Service-Information Motorcycle

Group: 31
Front Forks

September, 1988
31 023 88
(2326)

Noisy Upper Fork Spring Support - '85 R65, R80, R100 Models

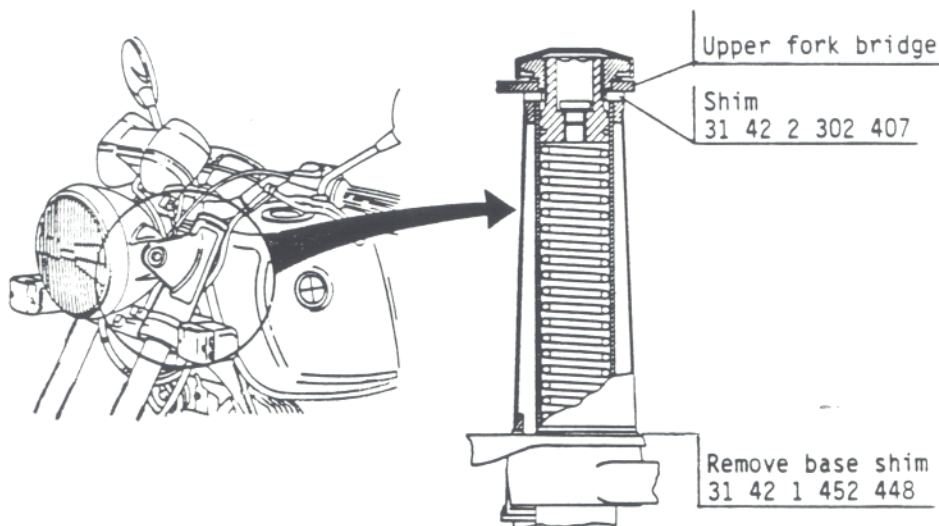
Problem: The fork spring support nut might work loose at the top fork bridge, causing an audible rattle.

Cause: The fork tube radius is pressing into the top fork bridge.

Remedy: Should this condition occur, install a shim:

Part no. 31 42 2 302 407

between the fork tube and top fork bridge to prevent the tubes from pressing into the casting.

Important:

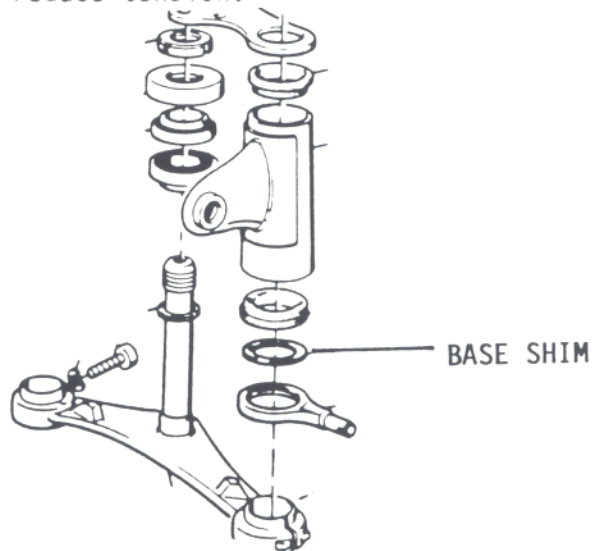
The headlight holders on the basic R65 and R80 are secured between the upper and lower bridge with rubber rings. A base shim - part no. 31 42 1 452 448 - must be removed to reduce tension.
